ARCHITECTURAL REVIEW BOARD MEETING

PROJECT COMMENTS

PROJECT NUMBER: SP2024-040
PROJECT NAME: Site Plan for 5543 Horizon Road
SITE ADDRESS/LOCATIONS: 5543 HORIZON RD

DEPARTMENT	REVIEWER	DATE OF REVIEW	STATUS OF PROJECT
PLANNING	Henry Lee	09/18/2024	Needs Review

SHEET NO
SP-1

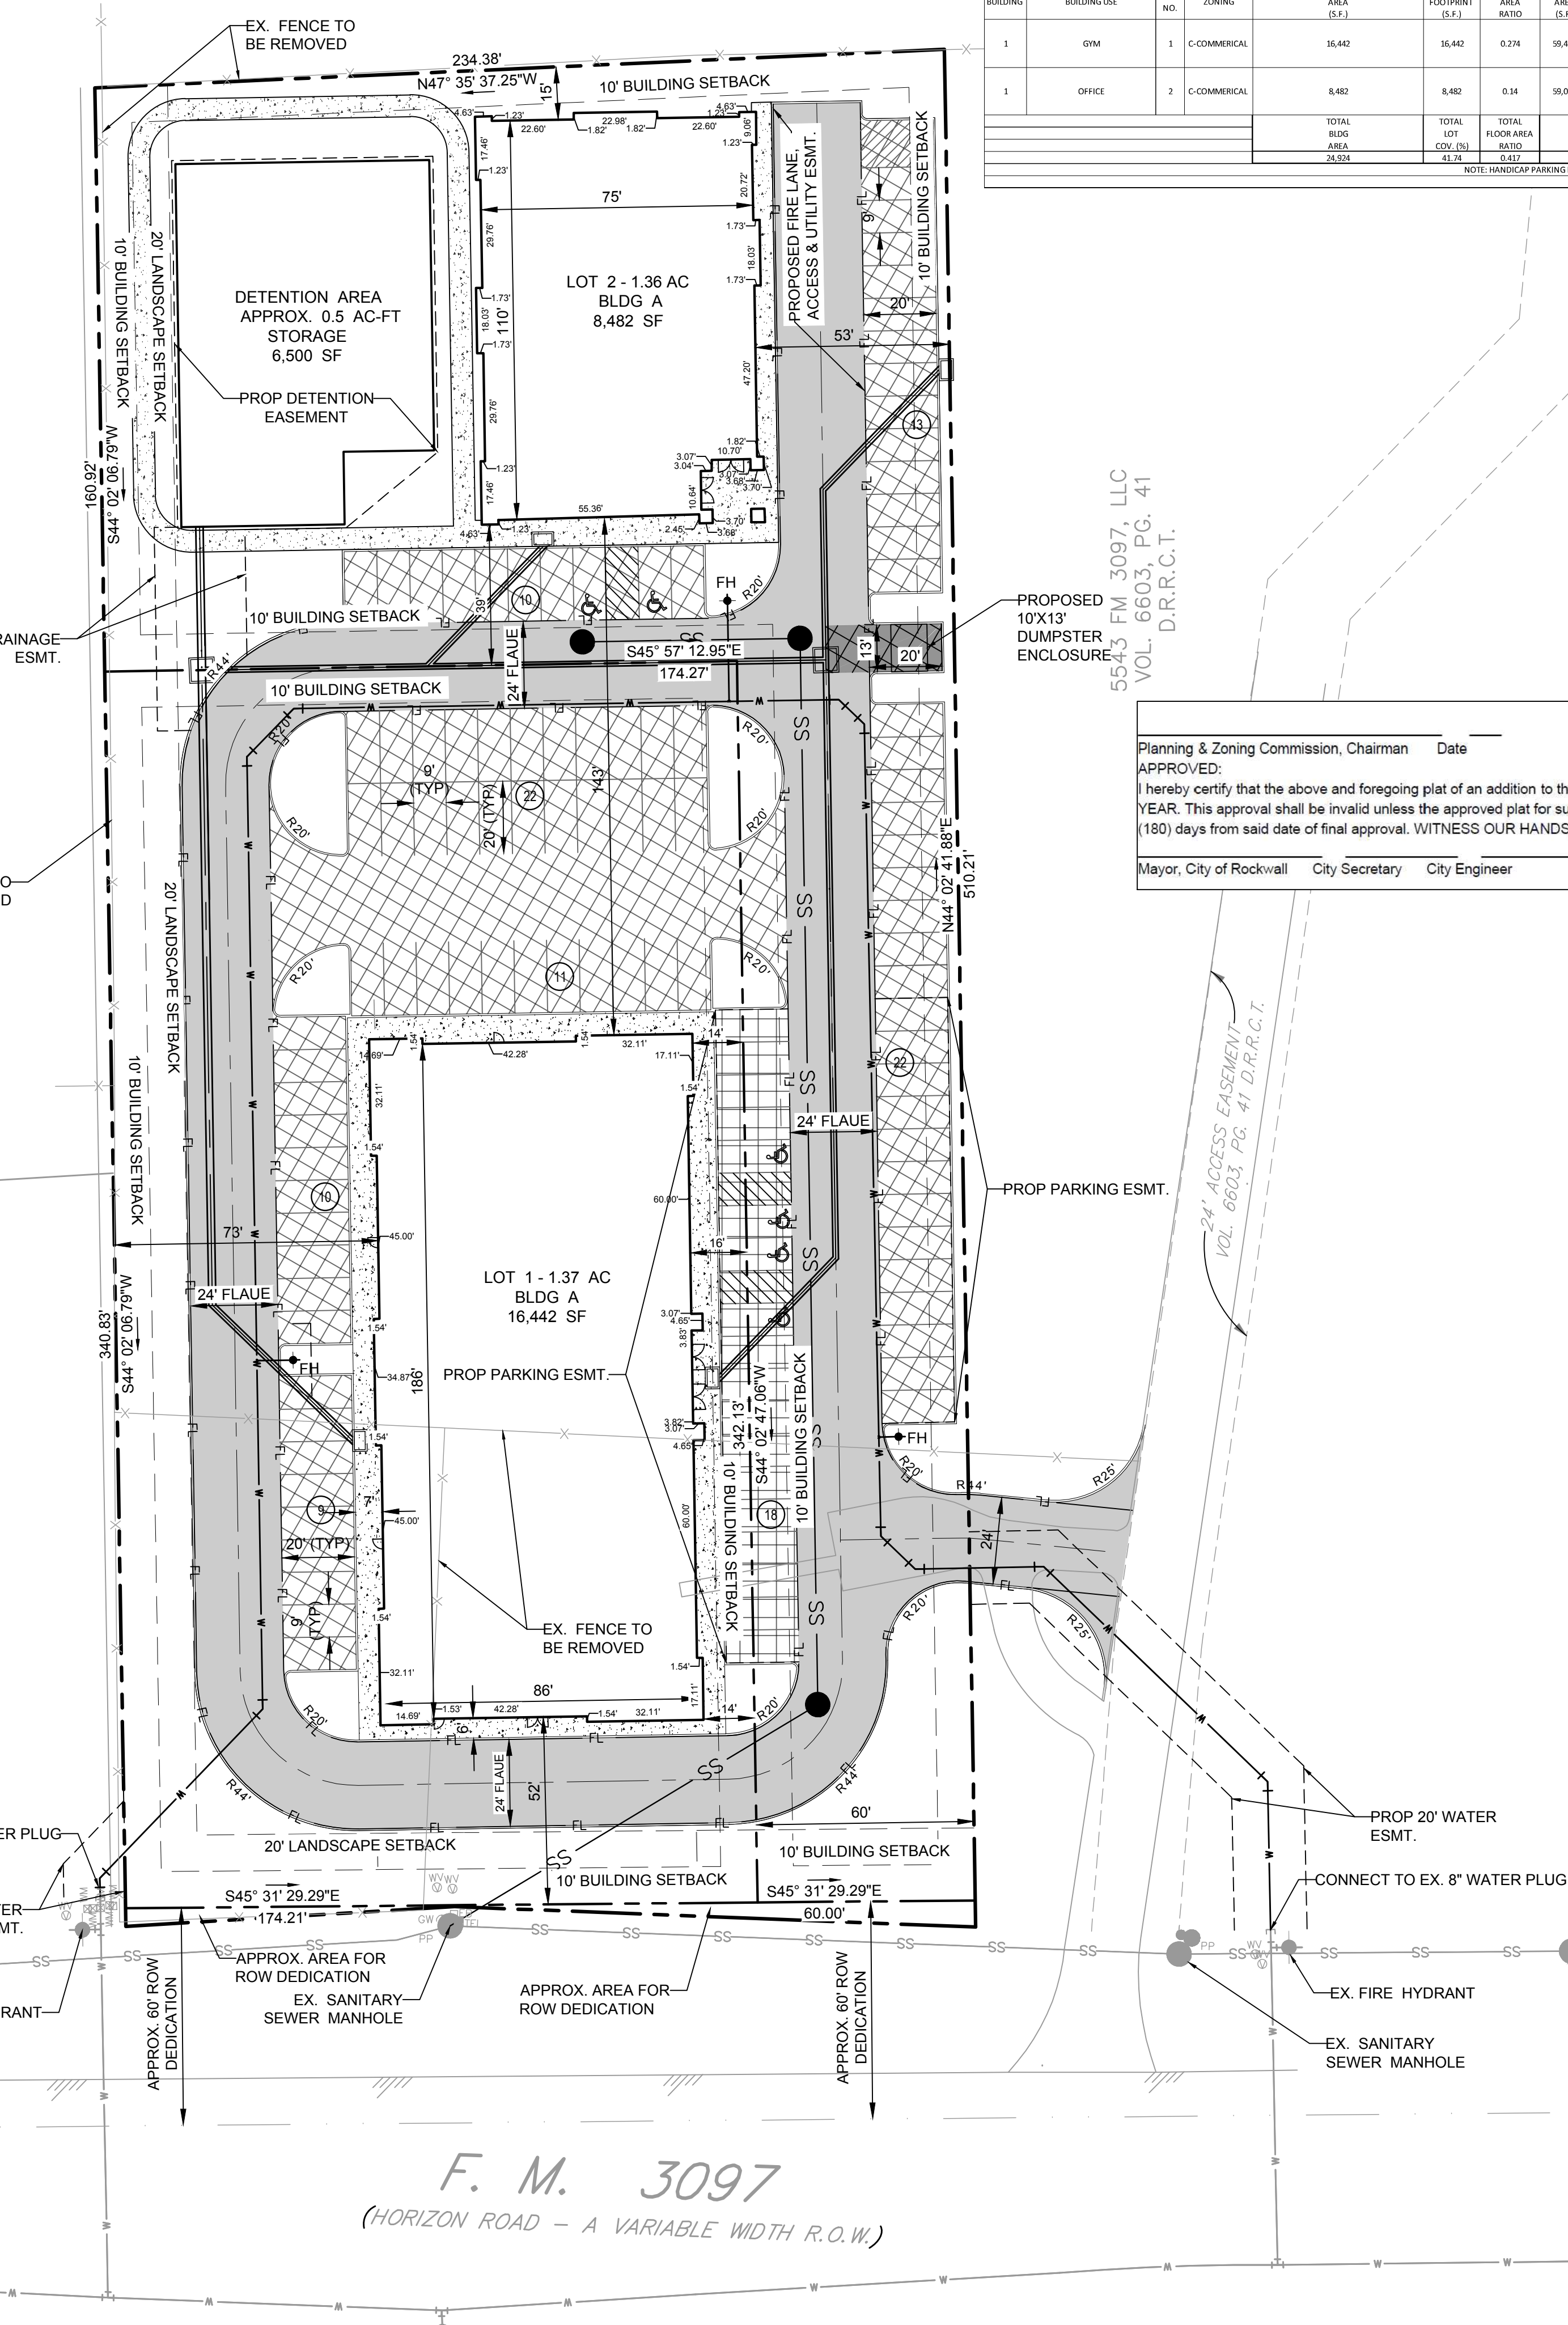
M.6 Site Plan.

- (1) Please provide the total site area in acres and square feet. (Subsection 03.04.B, of Article 11, UDC)
- (2) The front building setback is 15-feet, and the side yard setback adjacent to the residentially used property is 23-feet. (Subsection 03.04.B, of Article 11, UDC)
- (3) Please indicate the fire lane as Fire Lane, Public Access, and Utility Easement. (Subsection 03.04.B, of Article 11, UDC)

- (6) Please indicate the type and depth of the paving materials, and provide a detail or cut-sheet. (Subsection 03.02, of Article 06, UDC)
- (7) Will there be any new fencing associated with this development? If so, please delineate and label it on the site plan, and provide a detail. (Subsection 08.02.F, of Article 08, UDC)

- (8) Will there be any ground mounted or roof mounted utility equipment? If ground mounted, please indicate it on the site plan and provide the required evergreen shrub screening. If roof mounted, please crosshatch it on the building elevations. (Subsection 01.05.C, of Article 05, UDC)

- (9) Please provide a note that there will be no outside storage or above ground storage tanks. (Subsection 01.05.D, of Article 05, UDC)
- (10) Will there be any dumpster enclosures associated with this development? If so, please have it meet the dumpster enclosure requirements. (Subsection 01.05.B, of Article 05, UDC)

- (11) All signage will be reviewed through a separate permitting process. Please remove all signage from the site plan/landscape plan and the building elevations. In addition, signage may not be located within ROW or future ROW. (06.02. F, of Article 05, UDC)

- 09/17/2024:
- 1. Min. 64'x15' hammerhead striped as "No Parking" Make need to be a fire lane turn around.
 - 2. All FHs and meters will also require a 20' water easement. All FHs must be min 5' from parking areas.
 - 3. Trash enclosure will require oil/water separator to drain to storm sewer system.
 - 4. All FHs and meters will also require a 20' water easement. All FHs must be min 5' from parking areas.
 - 5. Show proposed TXDOT ROW
 - 6. Must be 24' wide reinforced concrete to meet fire lane requirements. If using the ex. driveway and adding onto it, you must core and test the existing paving to make sure it meets fire lane strength and standards.
 - 7. See next sheet for proposed ROW
 - 8. You will need water easement for this area as well.
 - 9. Min 10' wide.

The fire lane will need to extend to the public roadway. If using the off-site access easement, it shall be improved to a width of 24 feet and platted as a fire lane.

A1.2
 PROJECT #: 24216.50

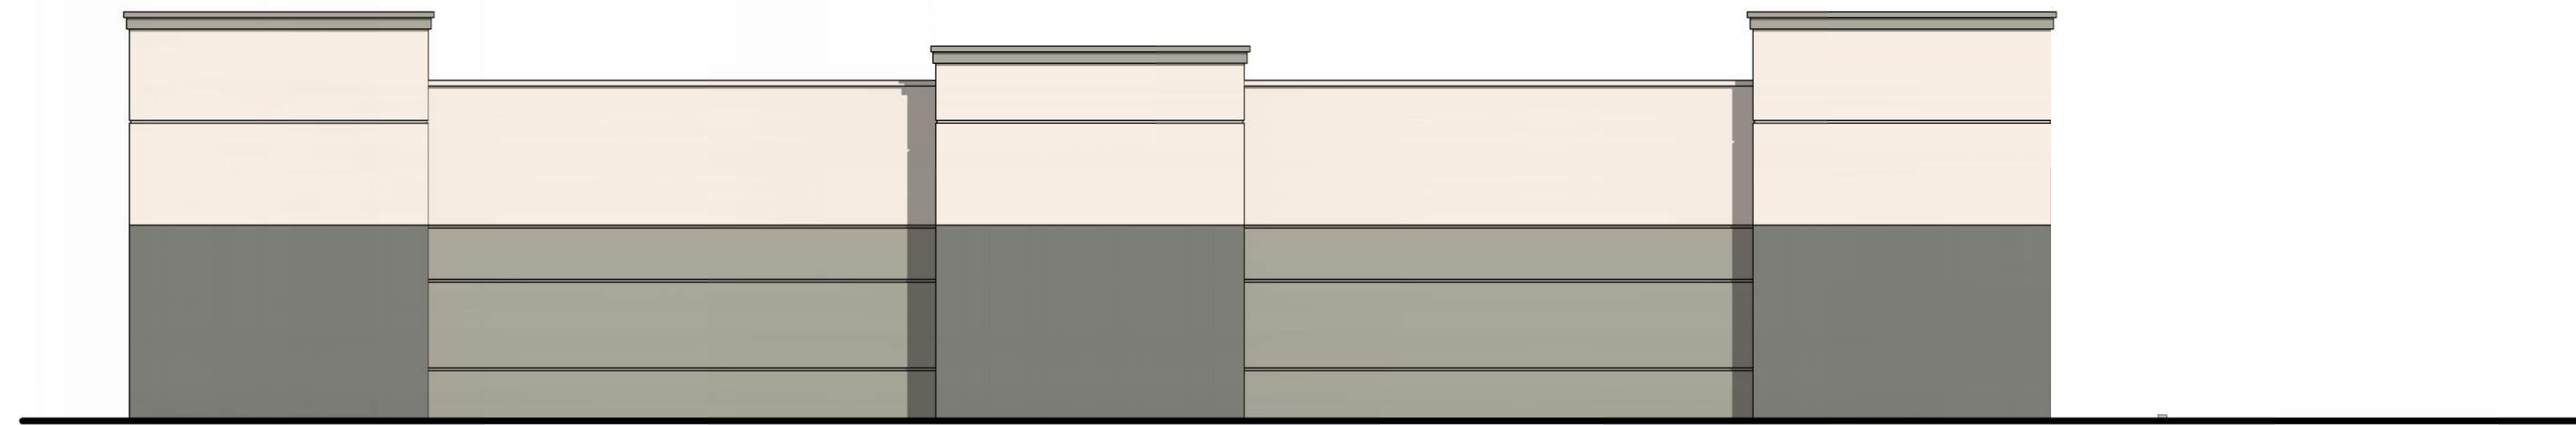
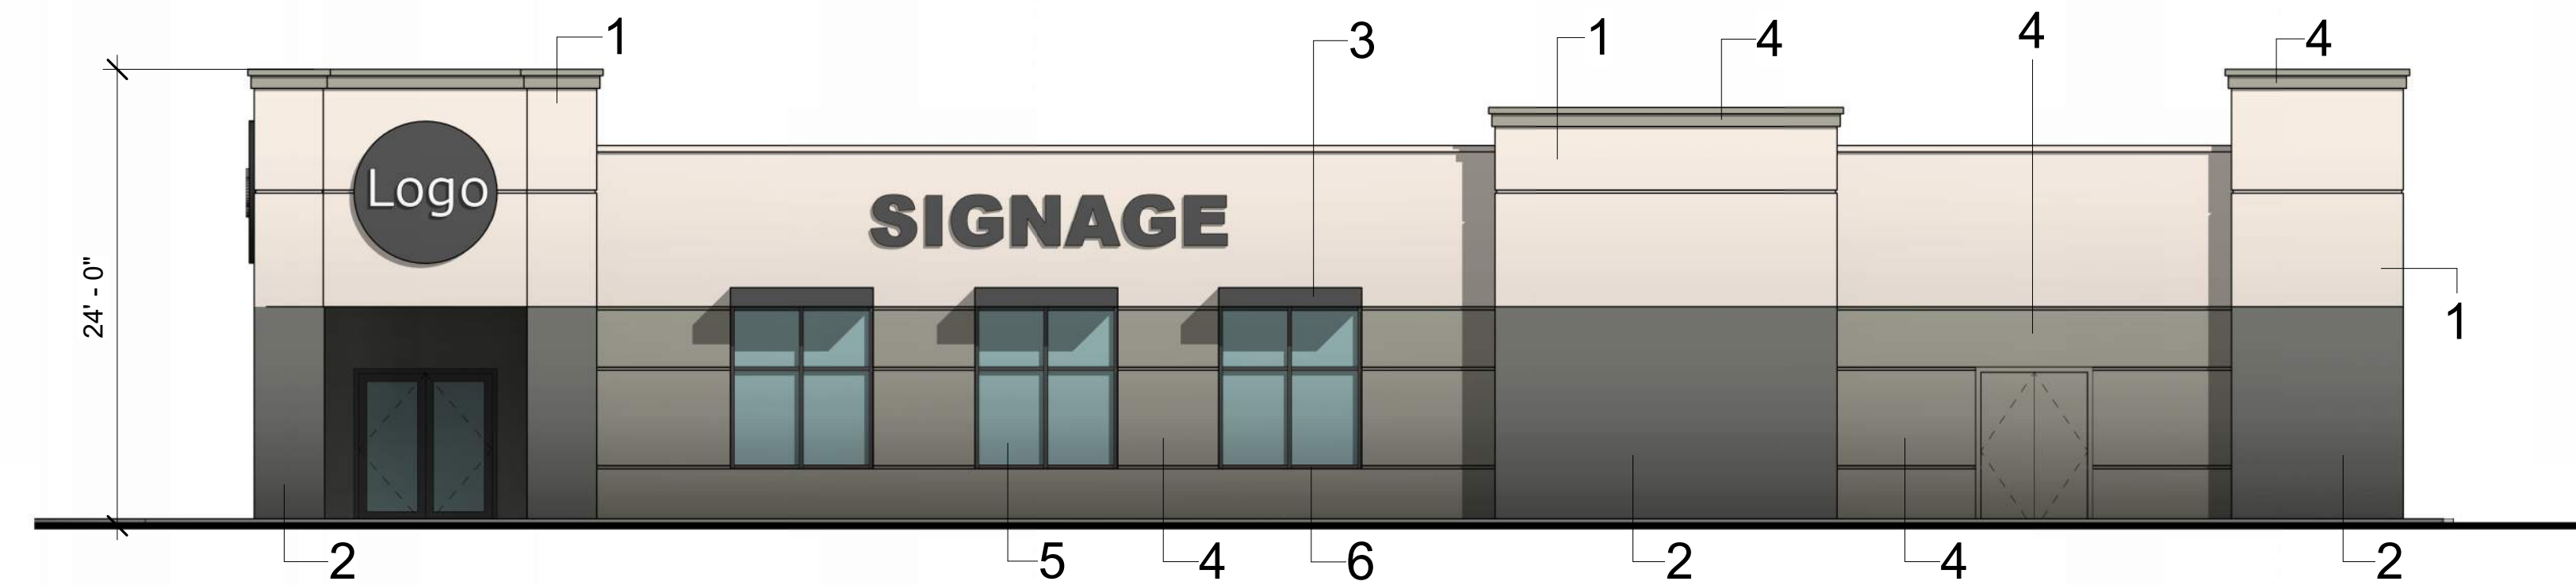
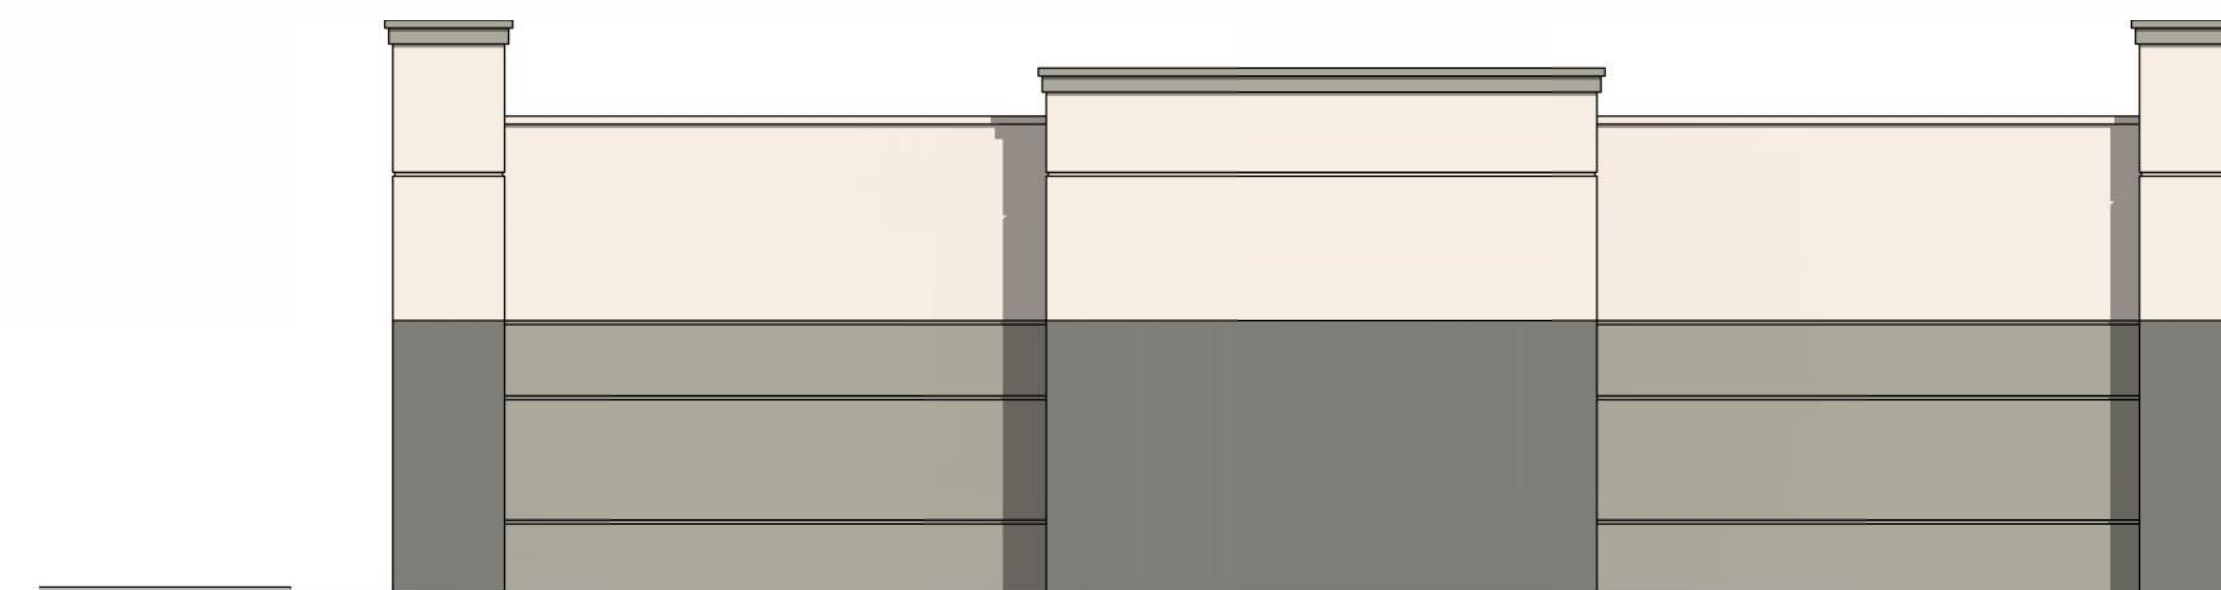
- (1) Please provide a table indicating the percentage surface area for each of the proposed materials on each building. This does not include doors or glazing. (Subsection 04.01, of Article 05, UDC)

- (5) Please indicate any architectural elements (such as cornice, arcades, and covered walkways/windows). (Subsection 04.01, of Article 05, UDC)
- (6) Both buildings do not meet the minimum articulation standards for buildings located within a Commercial (C) District. More specifically, both buildings do not meet items 3-6 on the primary facades, and items 3-5 on the secondary facades as described and depicted in Figure 7: Commercial Building Articulation Standards within the UDC. (Figure 7, of Article 05, UDC)
